Technical Information Bulletin

13-036

Routing Bracket on T300's with Hydraulic Brakes

11/4/2013

Hydraulic Reservoir Routing

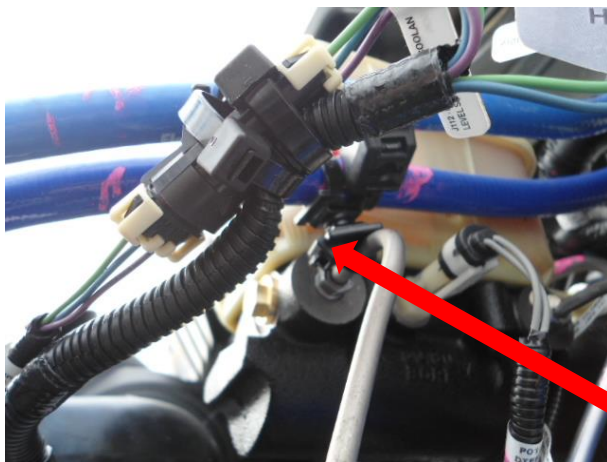
Beginning in April, a standoff was added to the reservoir mounting bolt on T300's with hydraulic brakes. The brake supplier does not approve the use of the reservoir mounting bolt to mount a bracket.

**REMOVE**

1. Identify if the hydraulic brake chassis has a standoff bracket attached to the brake fluid reservoir mounting bolt.
2. Remove the reservoir mounting bolt that attaches the standoff bracket to the master cylinder. Be careful not to hit the nearby plastic Pressure Differential Switch as it can be damaged by wrench contact.
3. Remove the standoff bracket assembly.
4. Reinstall the reservoir mounting bolt and torque the bolt to 37.3 ± 3.4 Nm (27.5 ± 2.5 ft-lbs).
5. Re-secure the bundle that was attached to the standoff bracket.

**DCT11**
